CITY OF WEST DES MOINES
STAFF REPORT COMMUNICATION

ITEM: Fareway Stores, Inc., SE corner of Mills Civic Parkway & S. 91st St – Approve a Preliminary Plat to create 2 lots and Approve a Site Plan to allow construction of a grocery store – Fareway Stores, Inc. – PPSP-005421-2021

Resolution: Approval of Preliminary Plat and Site Plan

LANDSCAPING PLAN

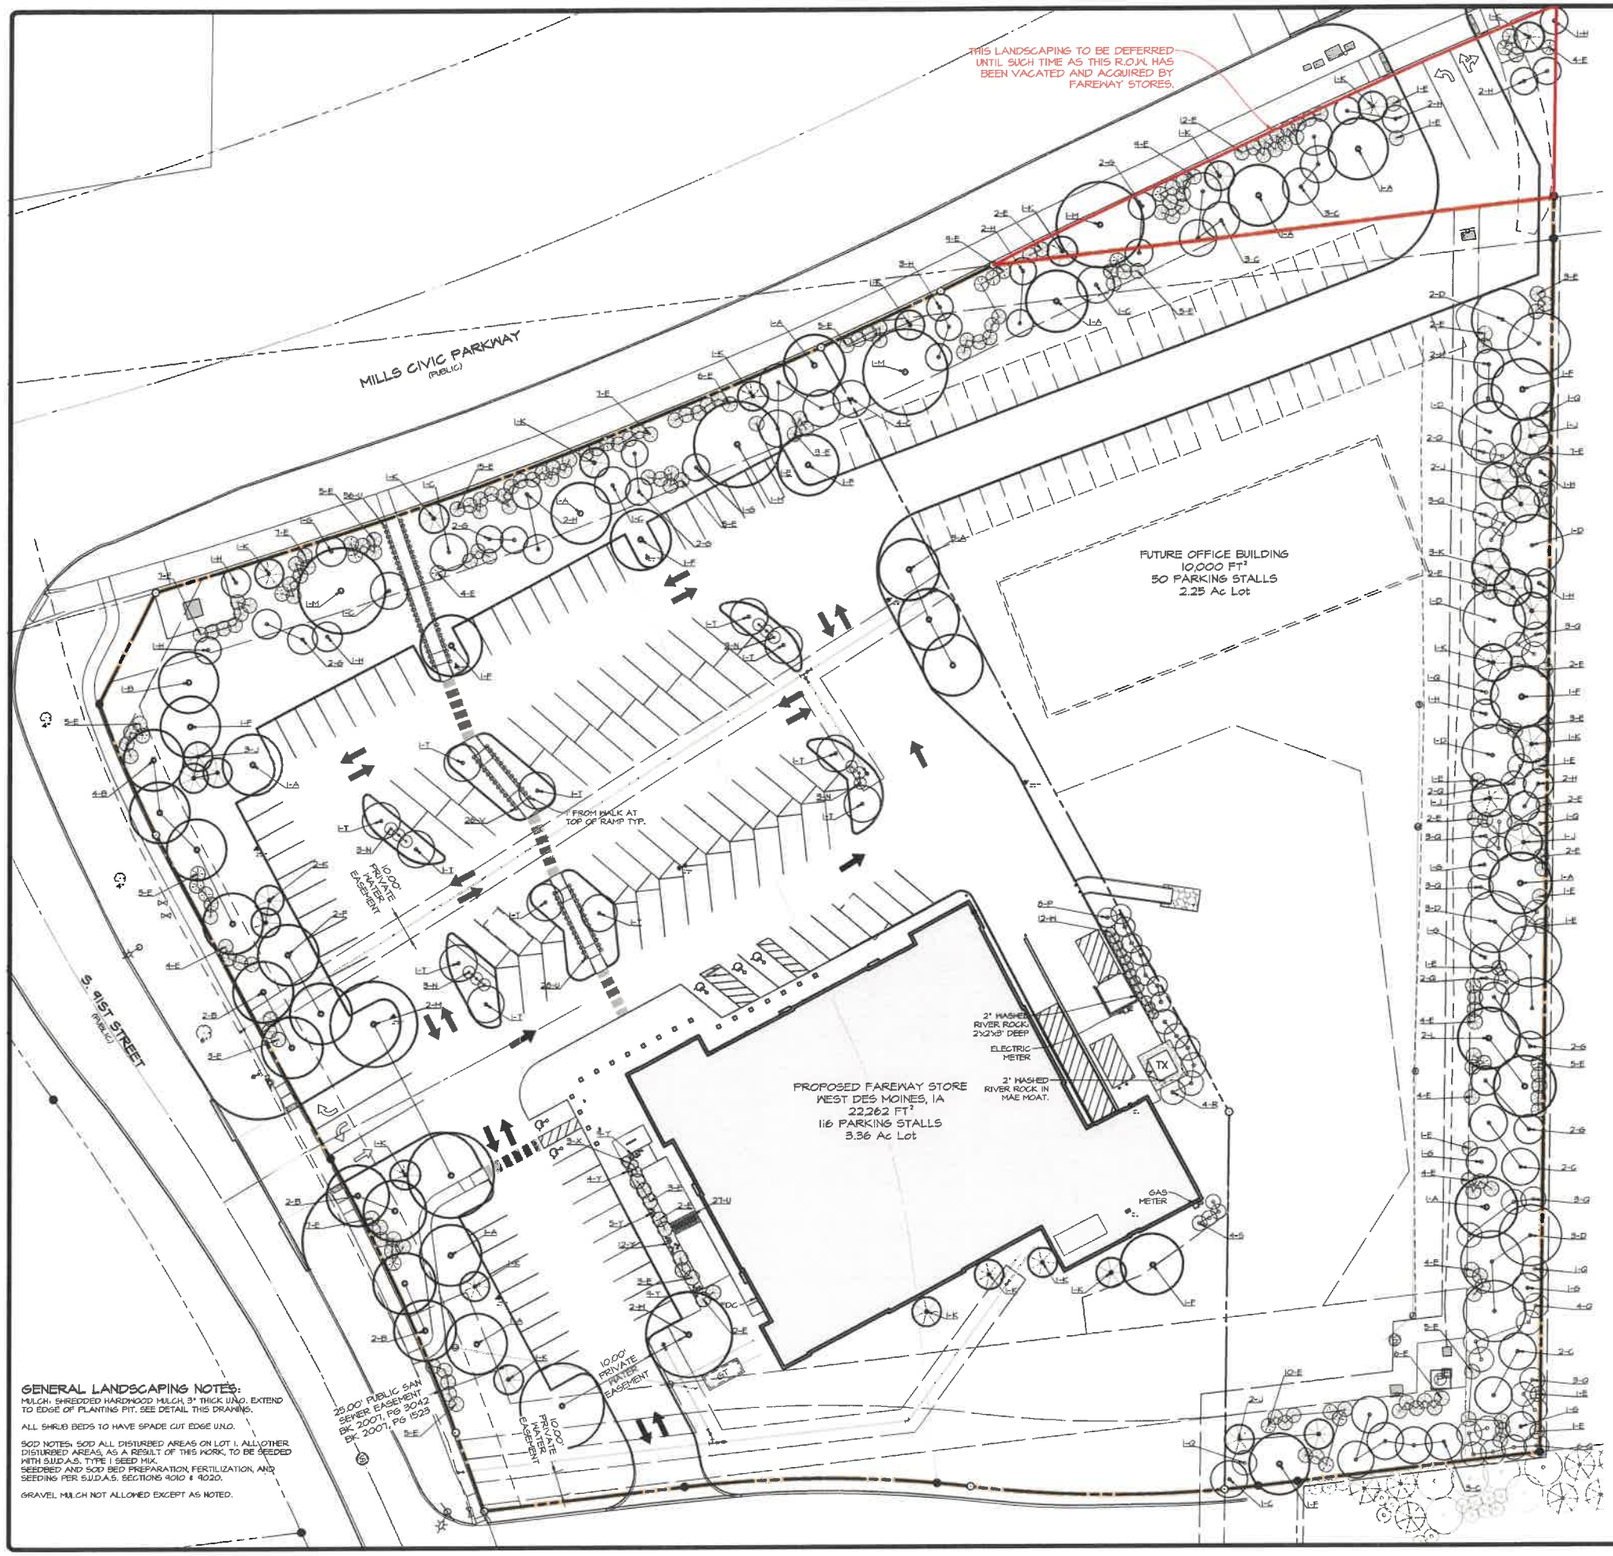
- *Key Development Aspects:*
  - Landscape Buffers: According to the requirements of the PUD, the development must provide streetscape landscaping within the first 15' parallel to the S. 91st Street right-of-way. Additionally, in accordance with the zoning code, the development must provide 30' landscape buffers along the balance of the perimeter boundaries of the property. There is a segment of buffer area along the south property line that is not necessary as part of this development proposal because said buffer landscaping was required to be installed as part of the abutting Elevate residential project. Therefore, the applicant is only required to provide landscape buffering within the southeast corner of the subject property. Lastly, the northeast corner of the larger property (future Lot 2) is remnant right-of-way of the Mills Civic Parkway street improvement project. The applicant is requesting deferral for a portion of this required buffer area that is currently dedicated public right-of-way. A condition of approval is recommended requiring the applicant install the buffer when the excess right of way is acquired.

1. The City Council granting a deferral of the installation of a portion of the required buffer located in the northeast corner of proposed Lot 2 that is currently remnant public street right-of-way. The applicant agrees to install this portion of the buffer once the right-of-way is conveyed.
